City of Port Phillip
Advertised Plan 1 of 40

28-32 ALBERT ROAD, SOUTH MELBOURNE
DRAWING LIST

AMENDMENTS TO ENDORSEMENT PLANS:

Project Title
28-32 ALBERT ROAD
SOUTH MELBOURNE

Drawing Title
ELEVATION - EAST

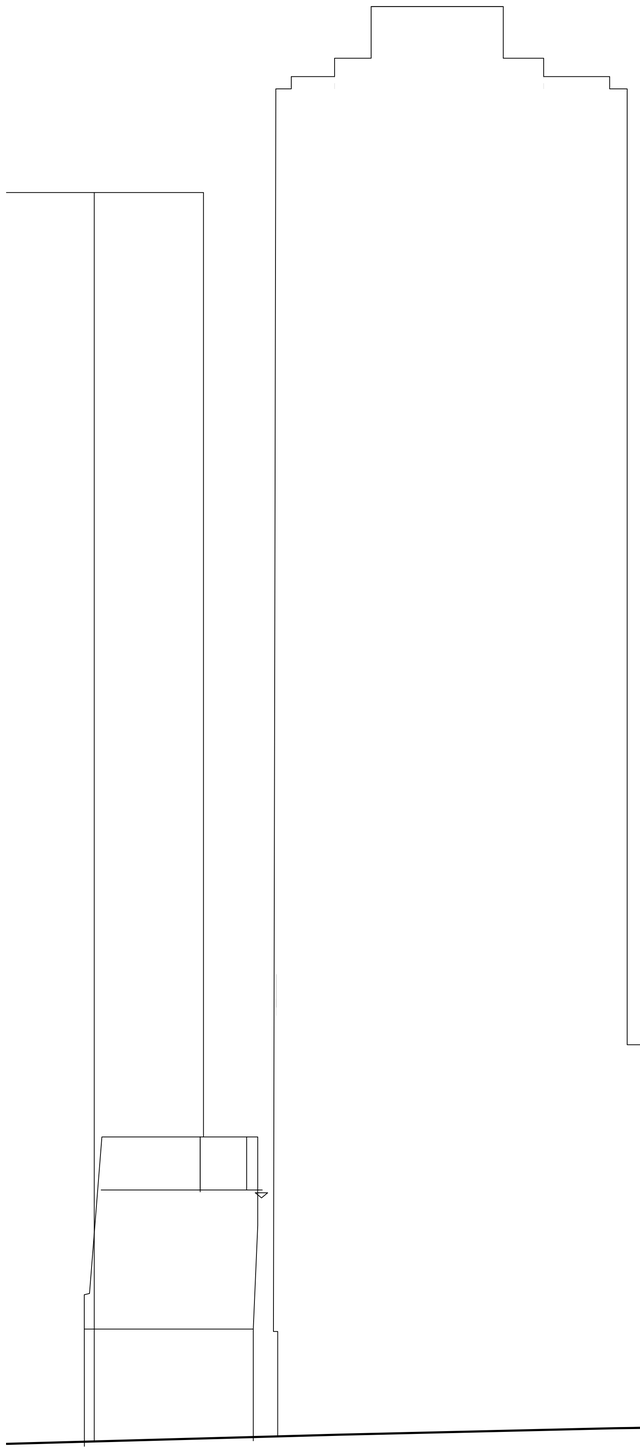
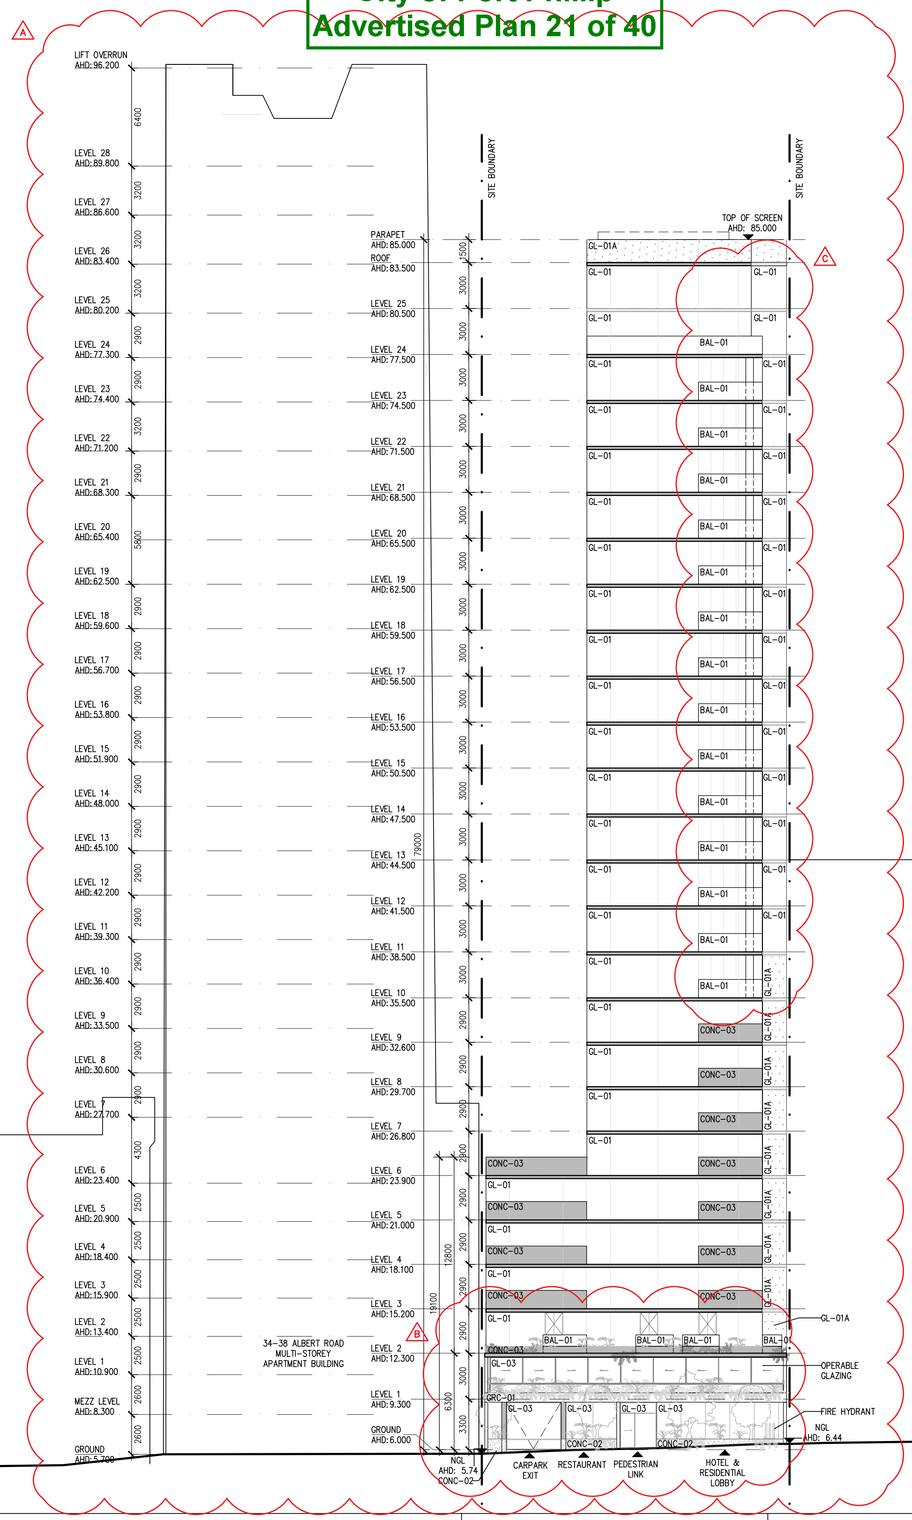
GROUND FLOOR PEDESTRIAN ARCADE ENTRY AND BOOSTERS ADJUSTED TO ACCOMMODATE REVISED LAYOUT

SLIDING WINDOWS AND PLANTER ZONE INTRODUCED TO L01 BAR FOR ENCLOSURE

C. RESIDENTIAL BALCONIES RATIONALISED TO SINGLE GREEN GLAZED BALUSTRADE IN PLACE OF GALVANISED STEEL PLANTER TO MATCH GREEN TOWER GLAZING

L11 - L25 NORTHERN GLAZING TO BE GREEN DGU IN PLACE OF SPANDREL GLAZING TO ACCOMMODATE REVISED APARTMENT LAYOUTS. L02 - L10 NORTHERN GLAZING REMAINS AS SPANDREL GLAZING

Drawing Title
ELEVATION - SOUTH

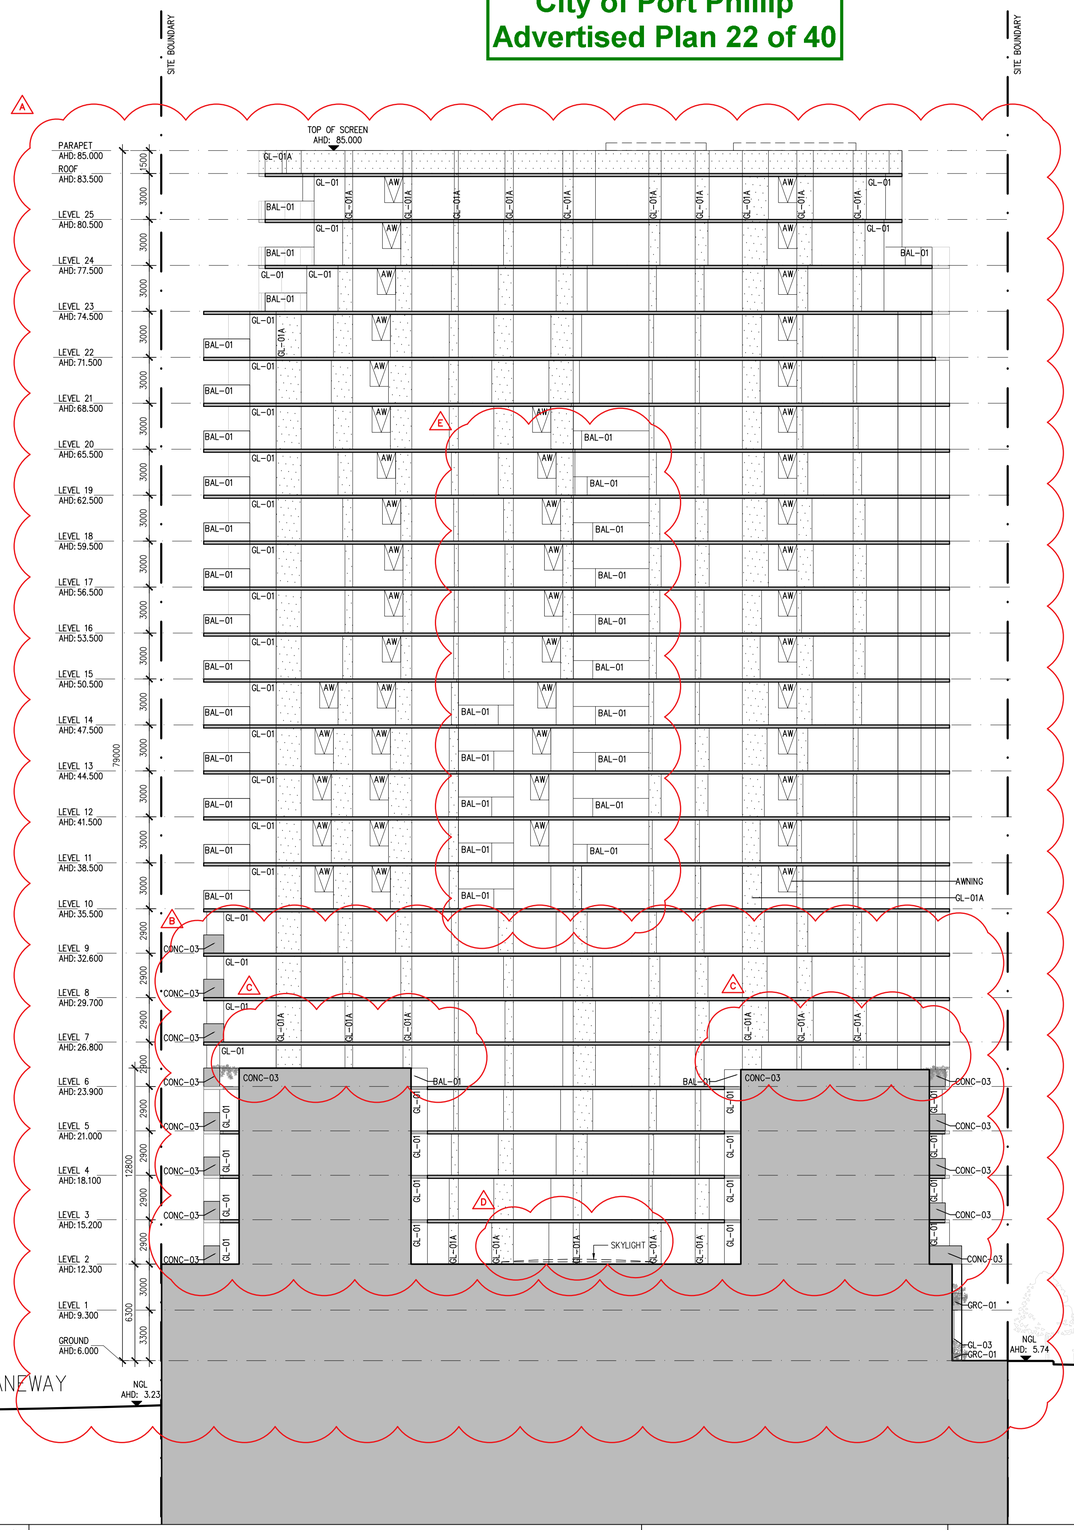
C. L06 TERRACES ADDED TO ACCOMMODATE REVISED HOTEL LAYOUT

D. SKYLIGHTS ADDED TO L02 ROOF

E. SOUTH FACING BALCONIES ADDED TO L10-20 TO ACCOMMODATE REVISED APARTMENT LAYOUTS

Drawing Title
ELEVATION - WEST

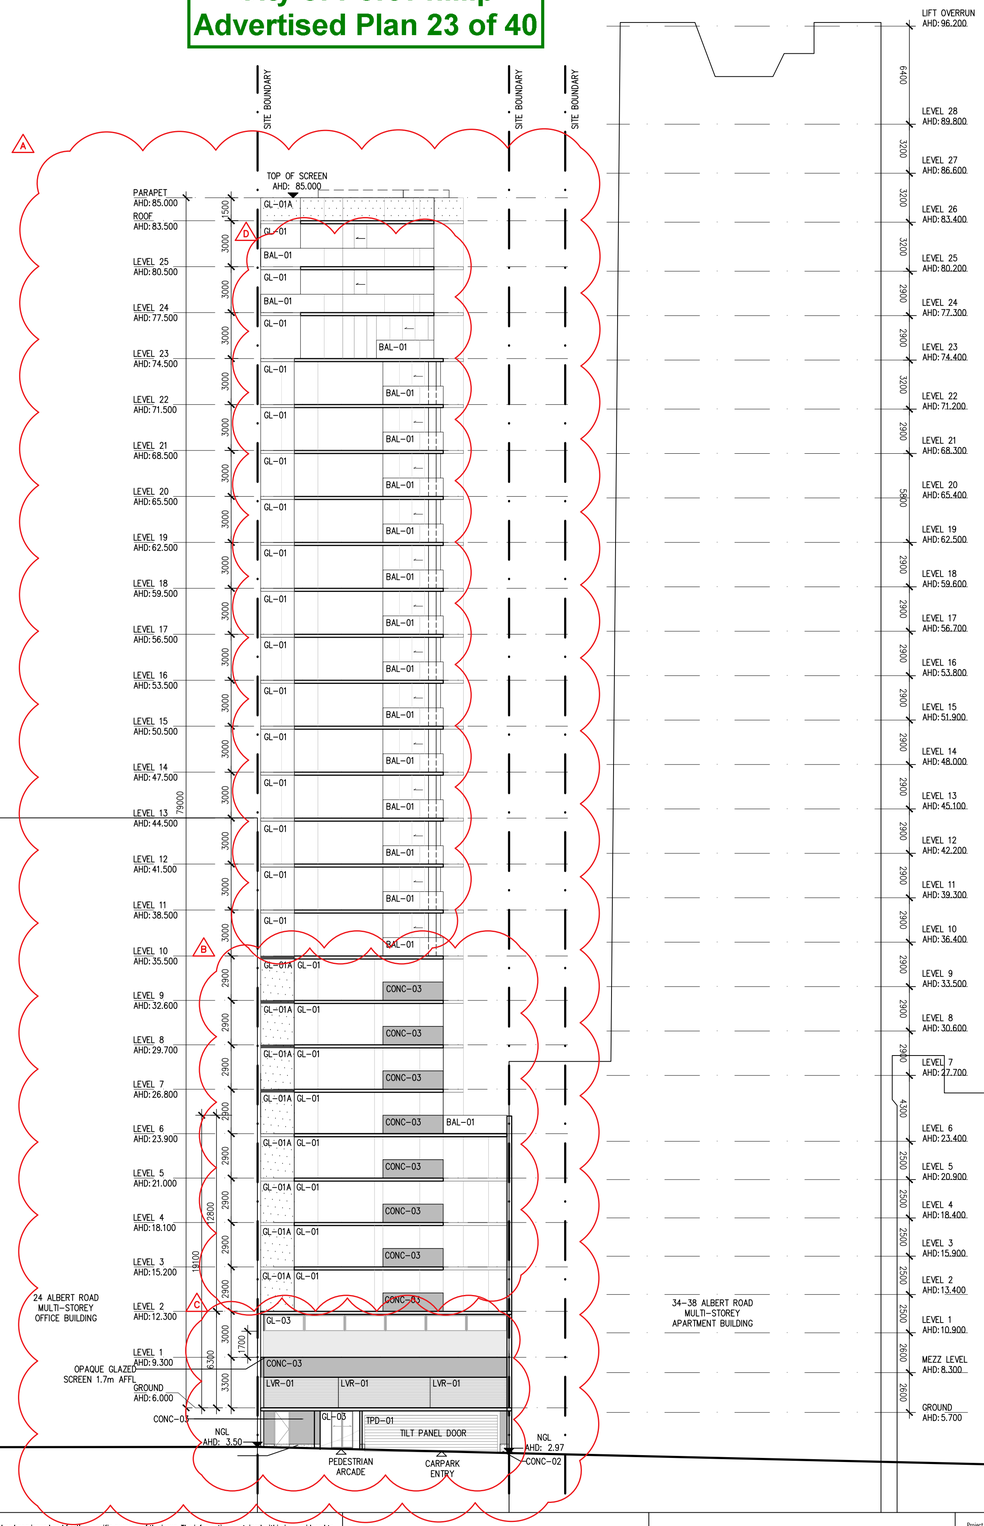
BALCONIES RECONFIGURED TO ACCOMMODATE REVISED APARTMENT LAYOUTS

PEDESTRIAN ARCADE ENTRY ADJUSTED. BOH ENTRY DOOR ADDED FOR ACCESS TO LOWER GROUND BOH AREA.

HORIZONTAL LOUVRE ADDED TO GROUND FAÇADE FOR AIR EXHAUST IN PLACE OF CLEAR GLAZING.

D. L10 – L25 NORTHERN GLAZING TO BE GREEN DGU IN PLACE OF SPANDREL GLAZING TO ACCOMMODATE REVISED APARTMENT LAYOUTS. L02 – L09 (HOTEL LEVELS) NORTHERN GLAZING REMAINS AS SPANDREL GLAZING

Drawing Title
SECTION A-A

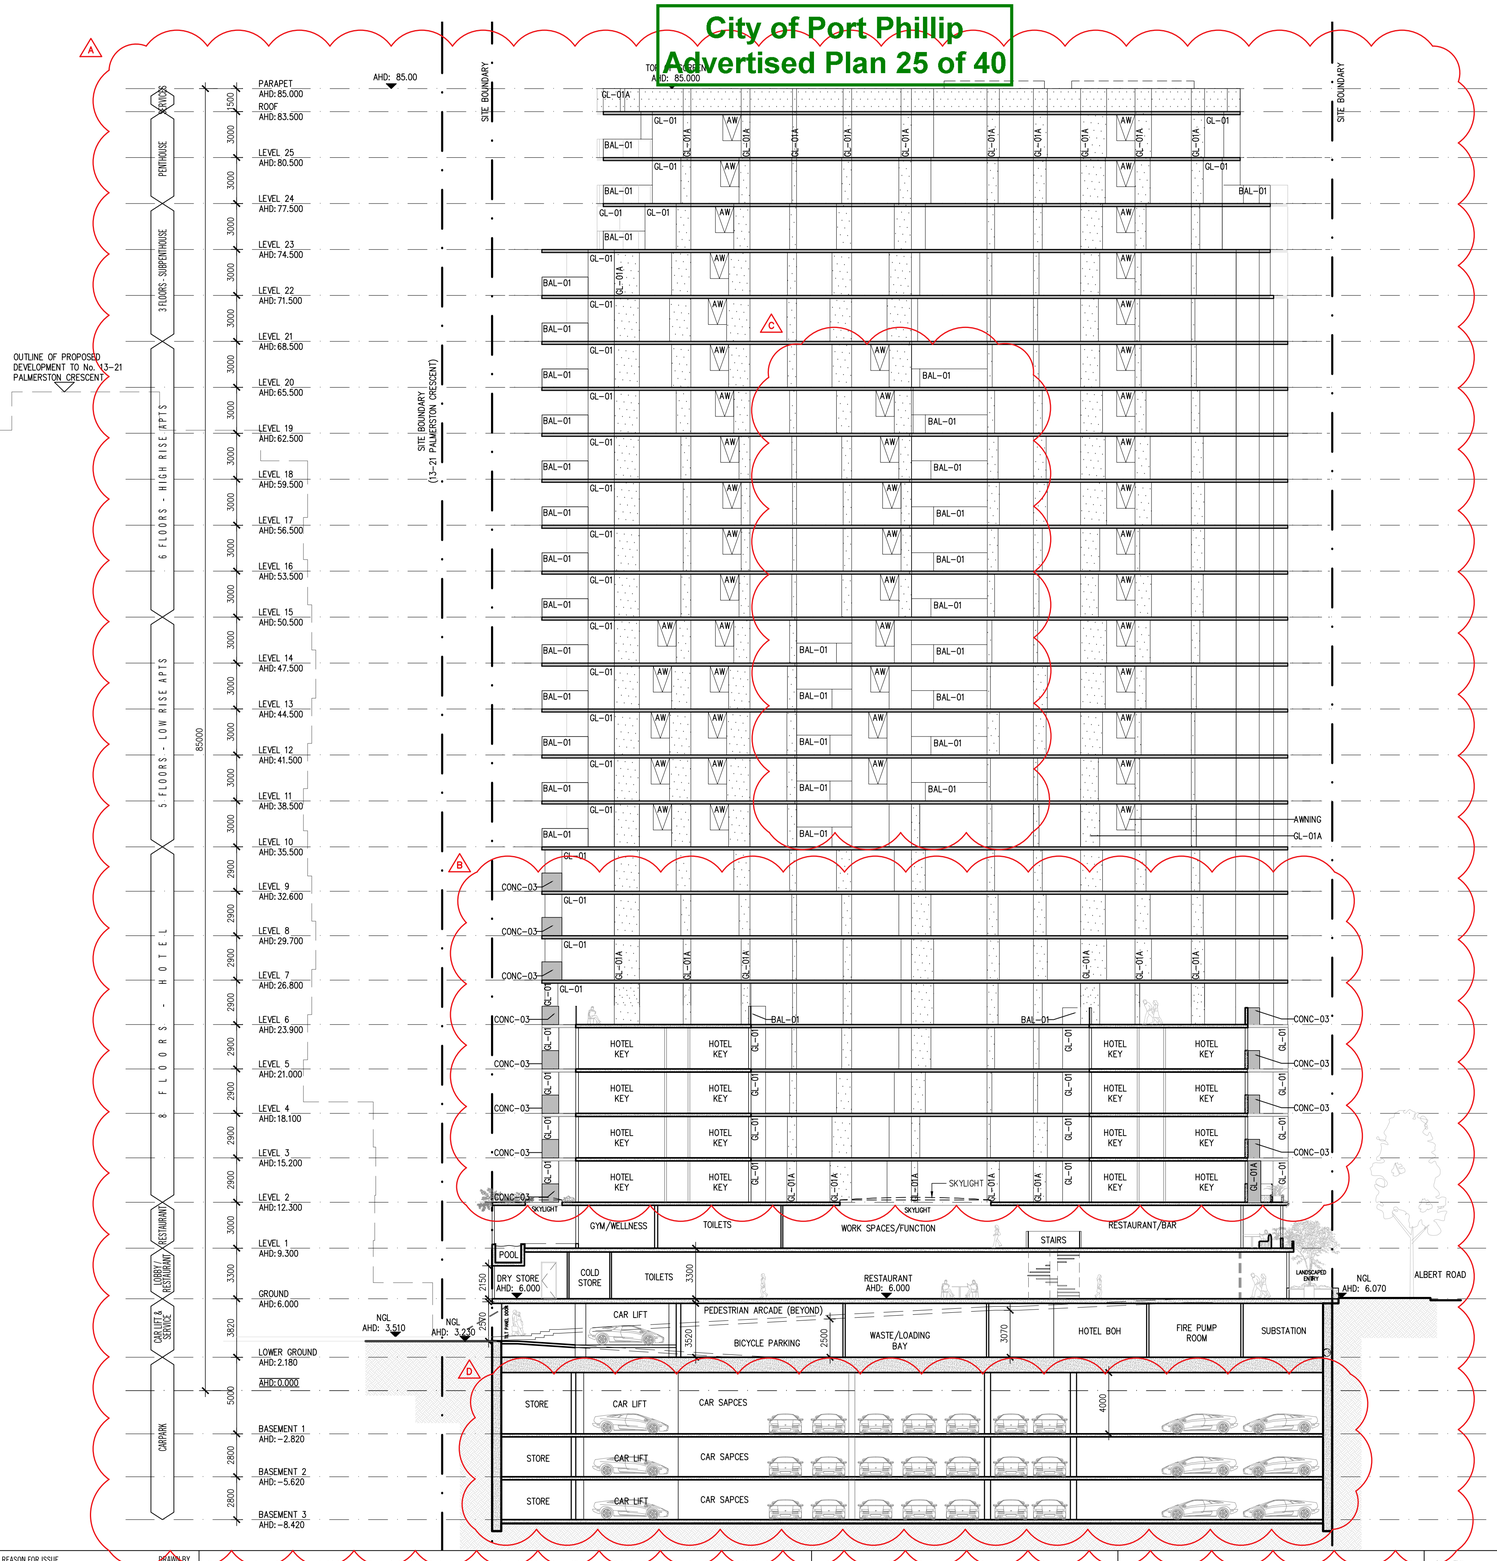
A. FLOOR LEVELS RATIONALISED TO ACCOMMODATE ADDITIONAL LEVEL

SECTIONAL LAYOUT UPDATED ACROSS ALL LEVELS TO REFLECT REVISED LAYOUTS

L06 TERRACES ADDED TO ACCOMMODATE REVISED HOTEL LAYOUT

SKYLIGHTS ADDED TO L02 ROOF

C. SOUTH FACING BALCONIES ADDED TO L10–20 TO ACCOMMODATE REVISED APARTMENT LAYOUTS

Drawing Title
SECTION B-B

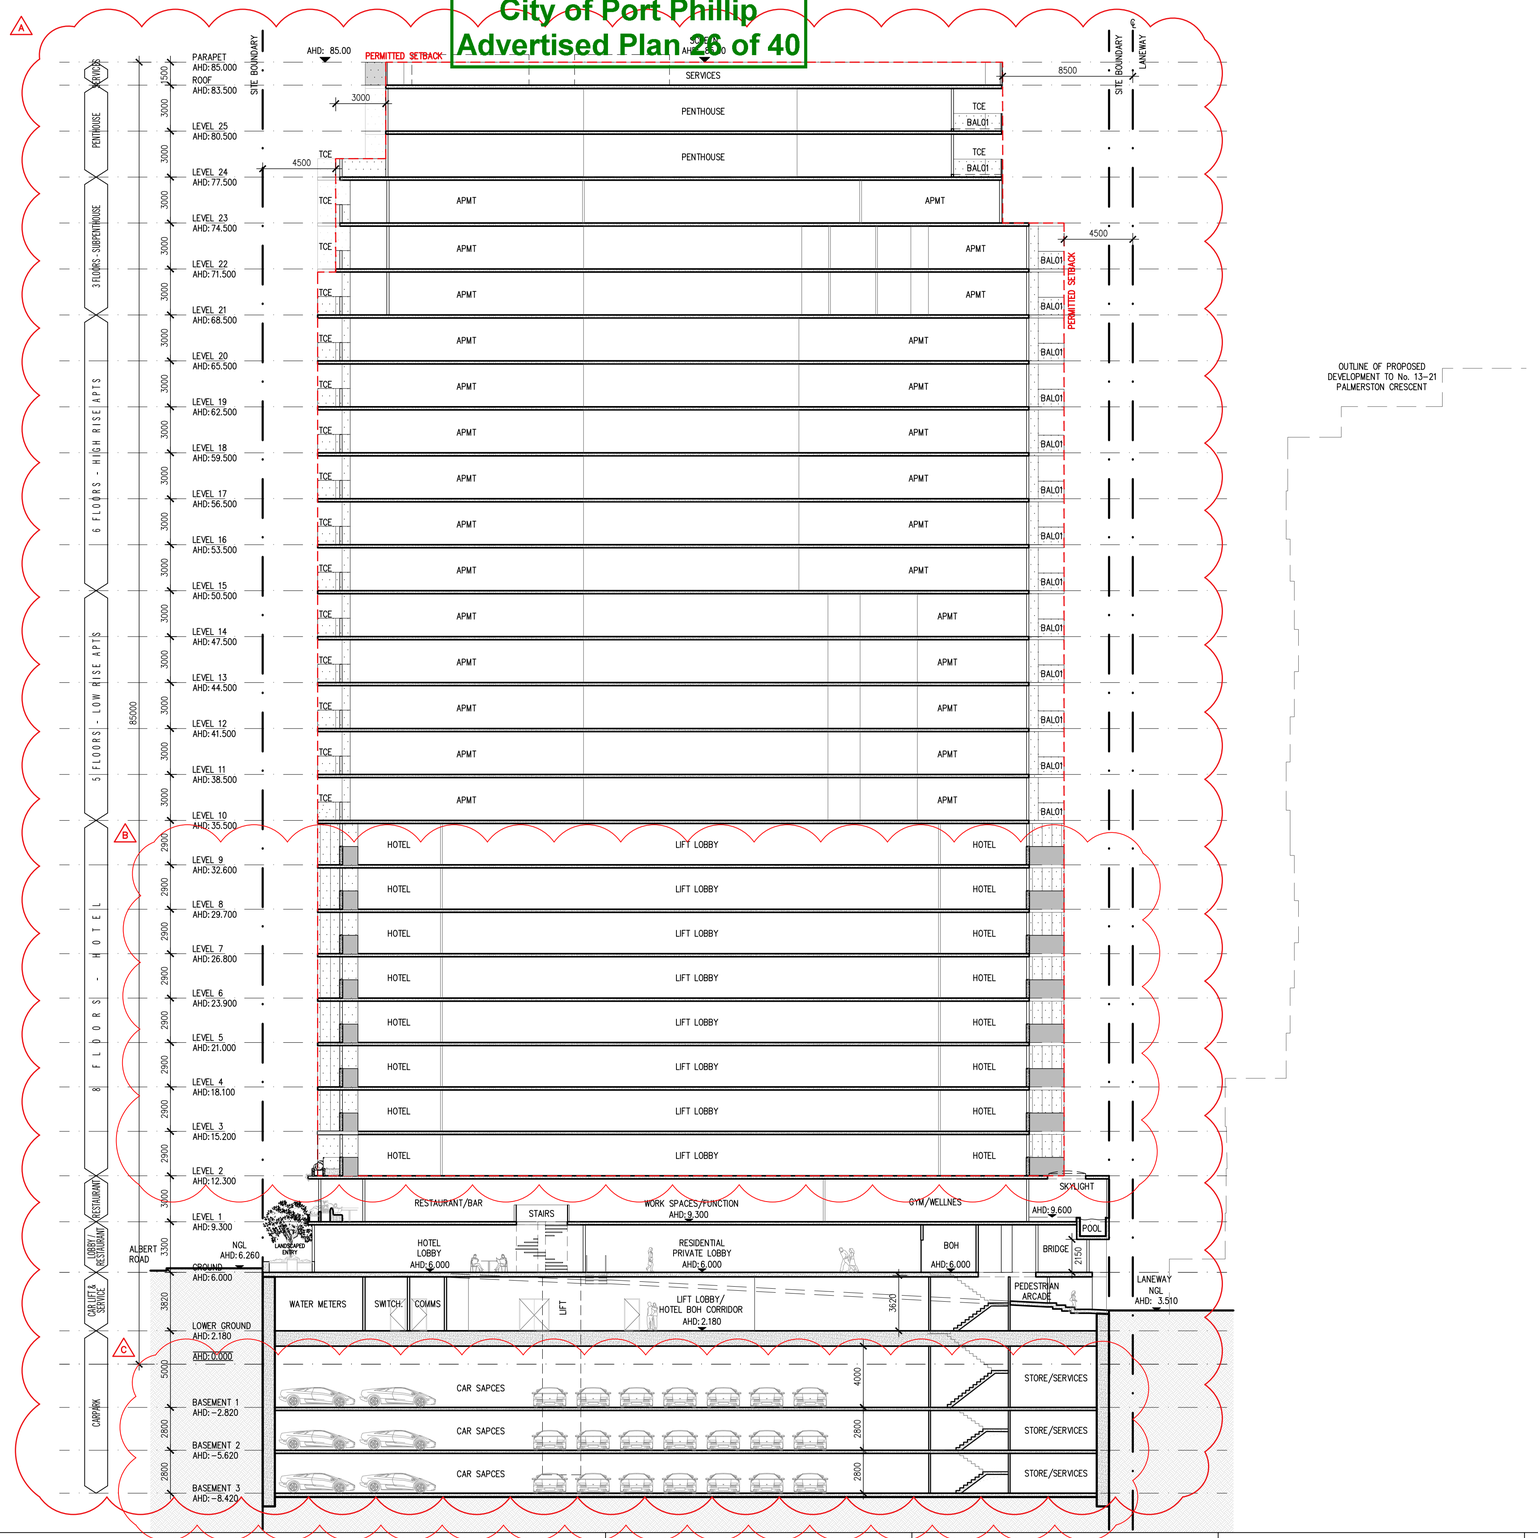
A. FLOOR LEVELS RATIONALISED TO ACCOMMODATE ADDITIONAL LEVEL

SECTIONAL LAYOUT UPDATED ACROSS ALL LEVELS TO REFLECT REVISED LAYOUTS

RED DASH LINE ADDED TO SHOW PERMITTED SETBACK
